A/YL-PH/1071

# DRAINAGE PROPOSAL

Lot No. 2807 (Part) and Lot No. 2808 (Part) in DD 111, Pat Heung,  
Yuen Long, New Territories

Submission of Drainage Proposal

(b) Proposed Drainage Plan

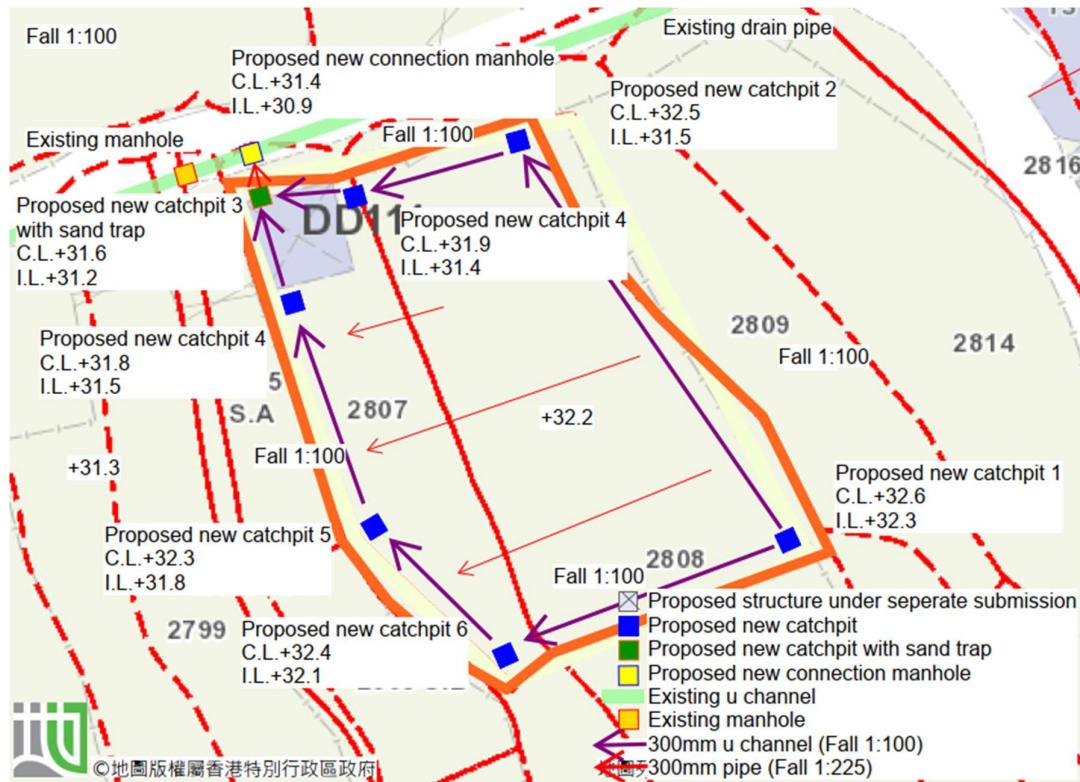
iii. Please confirm whether the gradient of all the proposed 300mm U-channels is 1:100 and it should be clearly indicated on the drainage plan for clarity.	Confirmed and indicated.
iv. Please indicate the size and gradient of the existing drainage facilities to be discharged from the site on the drainage plan for review. Please check and ensure the hydraulic capacity of the existing drainage facilities would not be adversely affected by the captioned development.	Noted and indicated.

v. Please provide a clear connection details at the discharge point with C.L. and I.L. (including plan view and cross section(s)) for further comments. The gradient and the size of	Noted.

<p>the proposed discharge drainage facility (i.e. pipe or u-channel, etc.) should be shown on the drainage plan.</p>	
<p>vi. The submitted photos cannot demonstrate the existing/internal condition of the existing drainage facilities. Please provide more site photos at different locations and views for reference. Please also advise the locations for photos taken for review. Besides, please indicate clearly the full alignment of the discharge path from the application site all the way down to the ultimate discharge point (e.g. a well-established stream course/public drainage system).</p>	<p>Noted and revised.</p>
<p>vii. The existing drainage facility, to which you proposed to discharge the storm water from the subject site was not maintained by this office. Please resolve any conflict/disagreement arisen for discharging the runoff from the application site(s) to the proposed discharge point(s). Moreover, please ensure that this drainage system and the existing downstream drains/channels/streams have adequate capacity to convey the additional runoff from the application site(s). Regular maintenance should be carried out to avoid blockage of the system.</p>	<p>Noted.</p>

Typical details for along hoarding

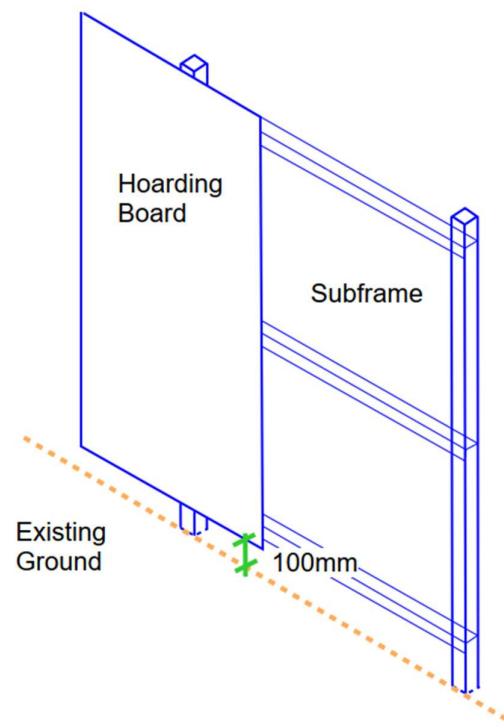
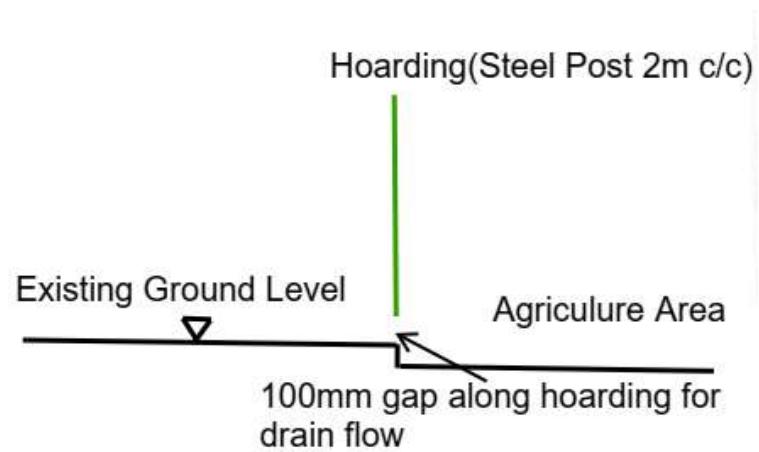
<p>viii. It is noted that a 100mm gap will be provided at the toe of the proposed hoarding. Please provide its details for further review.</p>	<p>Noted and provided.</p>
<p>ix. The development should neither obstruct overland flow and nor adversely affect existing natural streams, village drains, ditches and the adjacent areas, etc.</p>	<p>Noted.</p>
<p>x. Please resolve any conflict/disagreement with relevant lot owner(s) and seek permission from DLO/YL for laying new drains/channels and/or modifying/upgrading existing ones in other private lots or on Government Land, where required, outside the application site(s).</p>	<p>Noted.</p>

(d) Cross section of existing and proposed ground levels

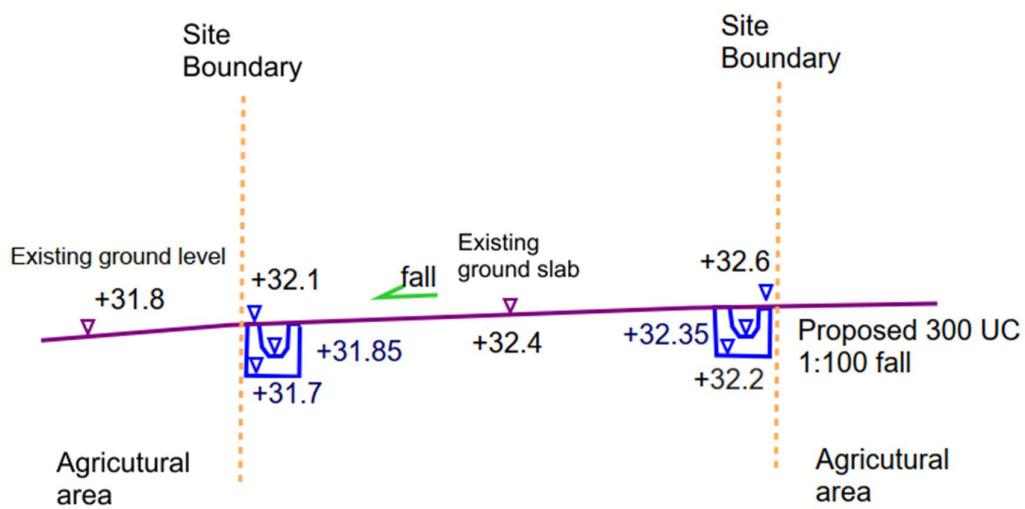
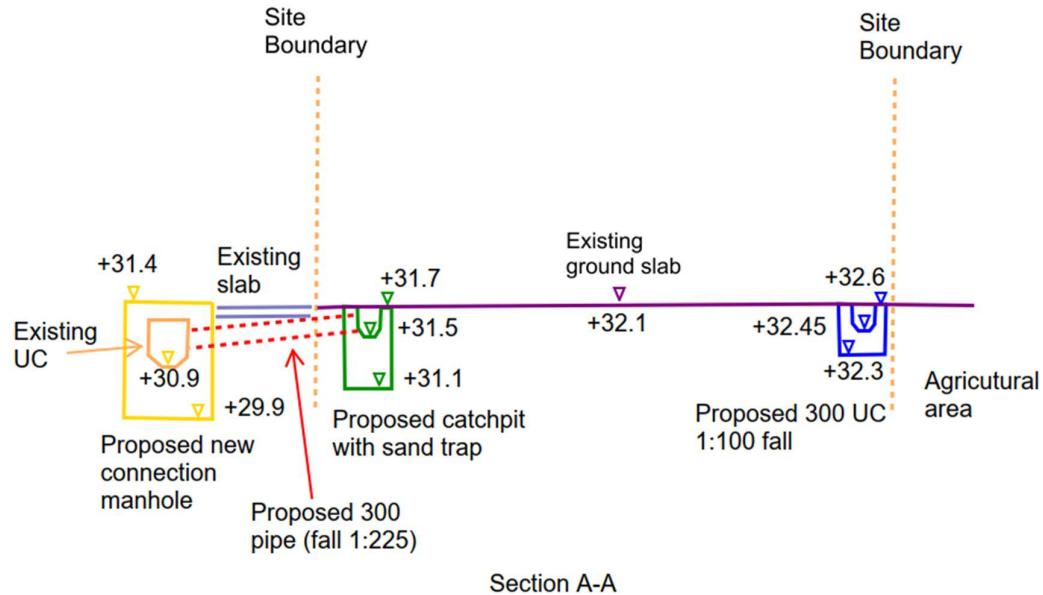
<b><u>Planning Application No. A/YL-PH/1071</u></b>	
Date: 10 Nov 2025	
<u>Comments from the Drainage Department</u>	
Comment	Responses
i. Please advise if any site formation/levelling works to be carried out under this application. Cross sections showing the existing and proposed ground levels of the captioned site with respect to the adjacent areas should be given. Referring to cross sections A-A and B-B, the proposed peripheral surface channels shall be provided along the site boundary at the original/existing ground level (instead of the revised ground level) to collect the surface runoff accrued on the application site and to intercept the overland flow from the adjacent lands. Please review.	No site formation/levelling works to be carried out under this application. Noted and revised.
ii. According to the drainage plan, the proposed invert level of CP3 at the downstream (+31.3) is higher than CP4 at the upstream (+31.1), which is not desirable from public drainage point of view. Please review.	Noted and revised.
